**SAN DIEGO GAS & ELECTRIC COMPANY (U 902-E)
INDEPENDENT PROFESSIONAL ENGINEER DISTRIBUTION PLANNING
ADVISORY GROUP REPORT**

INDEPENDENT PROFESSIONAL ENGINEER SDGE 2025 DPAG REPORT

Public Independent Professional Engineer SDGE 2025 DPAG Report

Figure 2-1: Number of Needs in the Past four DPP Cycles

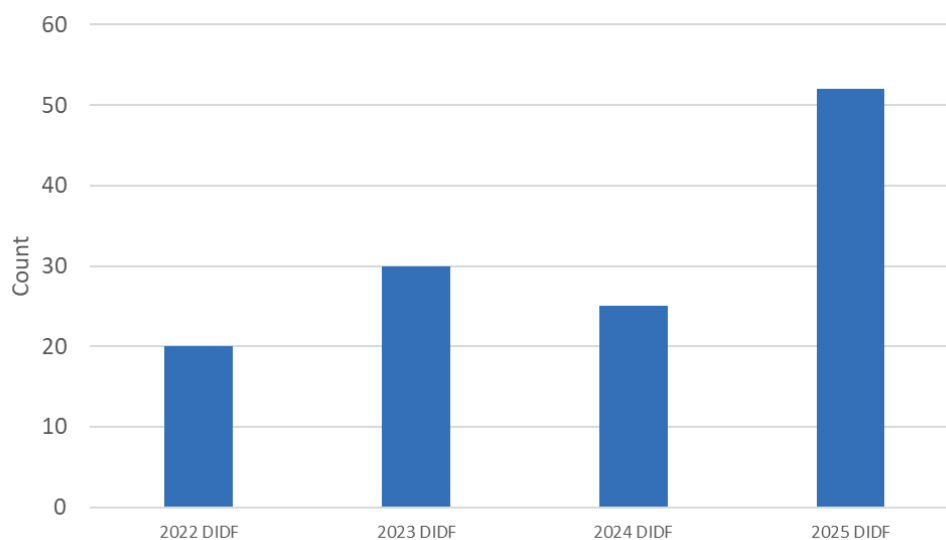
- The total number of grid needs in the 2025 GNA was significantly higher than those observed in the past cycles. In this cycle there were 52 needs compared to 25, 30 and 20 needs in the 2024, 2023 and 2022 GNAs respectively. The increase in the number of needs is primarily due to the increase in forecast load growth as discussed later in this section. Figure 2-1 shows the number of needs in the past four cycles.

Figure 2-2: Known Load Customer Types and Load (MW) in the 2024 and 2025 GNA

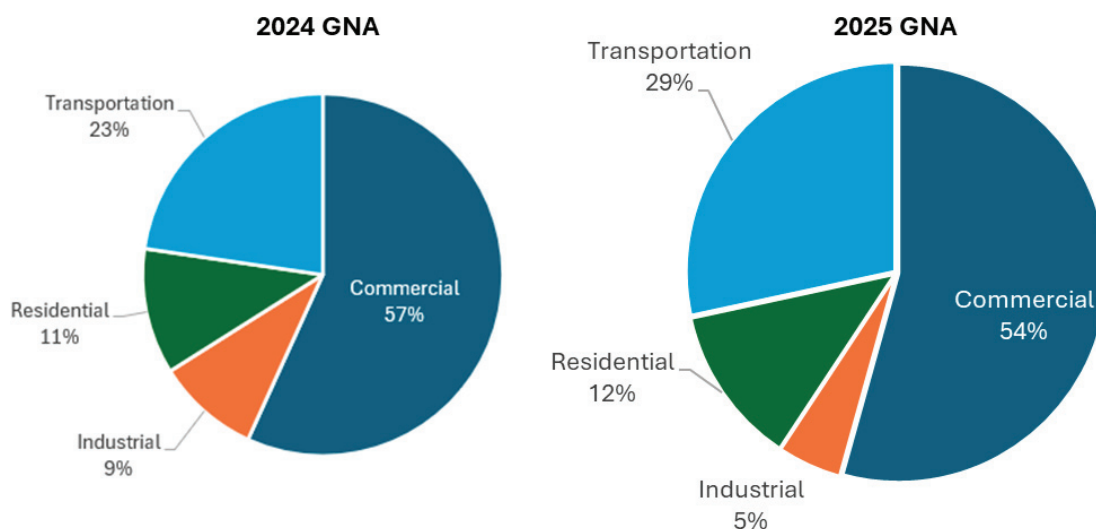
- The total known load additions across all the forecast years increased from 316 MW in the 2024 GNA to 433 MW in the 2025 GNA. While there was an increase in known loads across all the categories going from 2024 to 2025, the majority of this increase was due to Commercial and Transportation Electrification-related loads. A pie chart of the total known load additions by customer type is shown in the Figure 2-2 below for the 2024 and 2025 GNAs.

Figure-2-3: Cumulative load forecast growth for the 12-year forecast period

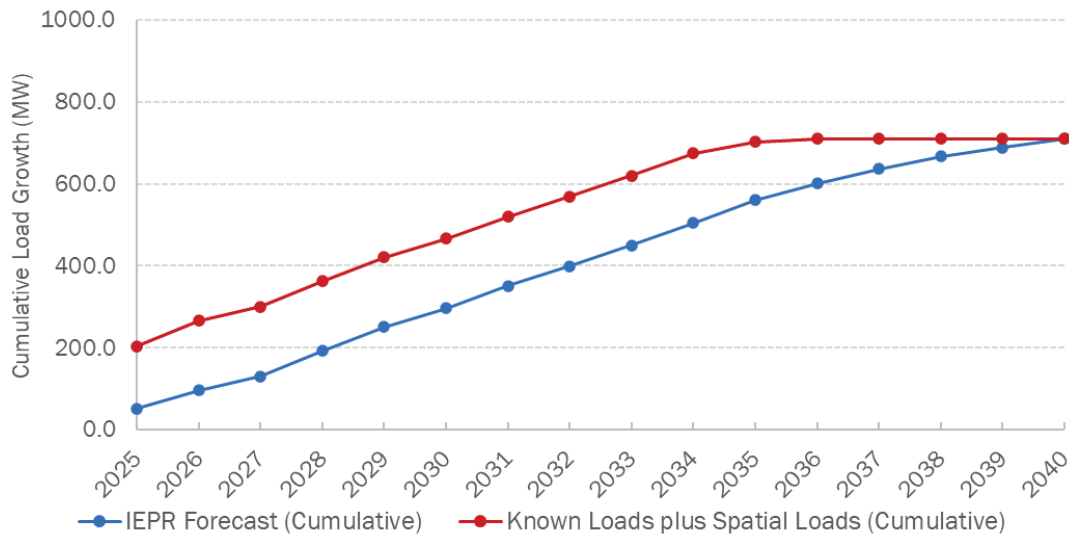
- Figure-2-3 and Figure-2-4 show a comparison of the IEPR load forecast and the load forecast used in the GNA on a cumulative and annual basis respectively. SDG&E transitioned to a new methodology for accounting for any differences between the IEPR forecast and known load requests in 2023 GNA cycle. SDG&E's methodology compares the IEPR forecast and the sum of the known loads on an annual basis (not on a cumulative basis) and assigns spatial load to the extent the annual IEPR forecast exceeds the annual sum of the known loads. (Known Loads are always modeled in the DPP analysis using the customer's indicated in-service year and circuit location.) The results of this new methodology can be clearly observed in Figure-2-4. It can be seen that in the first two years of the forecast (2025 and 2026), there are no spatial loads assigned to circuits since the sum of the known loads for that year exceeds the IEPR forecast.

Starting the third year (2027), spatial loads are assigned to circuits since the sum of the known loads in those years is lower than the IEPR forecast. When compared to the old methodology, this methodology has the effect of moving known loads to outer forecast years (2035 to 2040, in this cycle), such that the cumulative GNA forecast matches with the cumulative IEPR growth forecast by the last year of the forecast period, similar to the methodology used in the past.

Figure 6-2: Raw and Scrubbed Hourly Load (Amps) Profile for a Circuit

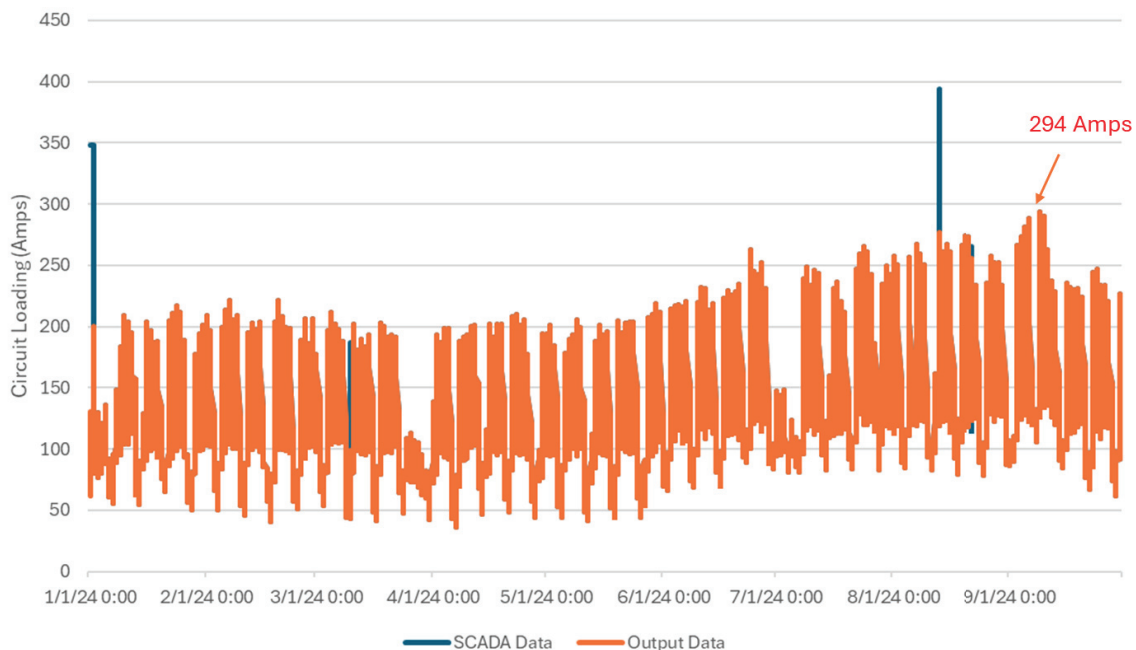
The IPE obtained the 2024 hourly raw SCADA data, as well as scrubbed data from SCADA Scrubber for all the circuits shown in Table 6-2. The raw and scrubbed data for one of the circuits is shown in Figure 6-2. In this figure, the instances of temporary load transfer and other spikes in loading can be seen in the raw SCADA data (blue). The scrubbed data is shown in orange. The peak of the scrubbed data matches with the value reported in Table 6-2 for this circuit.

Figure 6-12: Histogram of Difference between Forecast and Actual Loads

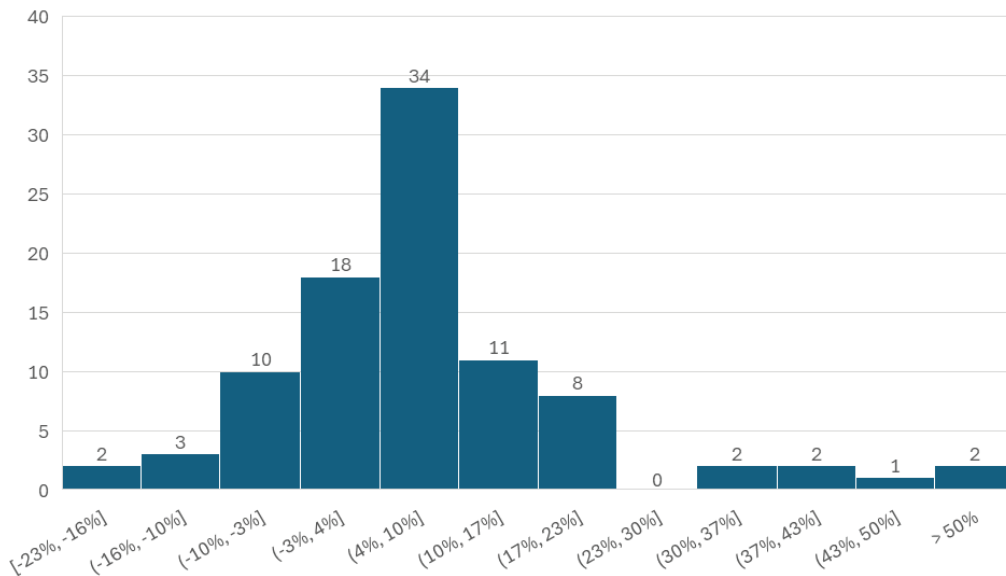
Verification: As in the prior cycle, the IPE obtained the forecast peak load for year 2024 for 10% of all circuit circuits from the 2024 GNA and the actual 2024 adjusted to 1-in-2 weather condition from SDG&E. SDG&E was not able to provide the actual 2024 peak load that was adjusted to a 1-in-10 weather condition since this value is not available in LoadSEER. Figure 6-12 shows the comparison where the difference between the forecast and actual expressed as percentage (of forecast) is shown as a histogram. It can be seen that for the majority of the sample circuits (69 out of 93 circuits), similar to the observation in the last cycle, the error is positive, i.e., forecast is higher than actuals. This is because we were comparing forecast loads that are based on 1-in-10 weather conditions with normalized peak loads which were under 1-in-2 weather conditions. The results of this type of comparison are highly dependent upon the weather conditions during the year, as well as transfers and G-1 included in the forecasts. The IPE will review if any changes are to be made to this step based on the availability of data to conduct the verification.
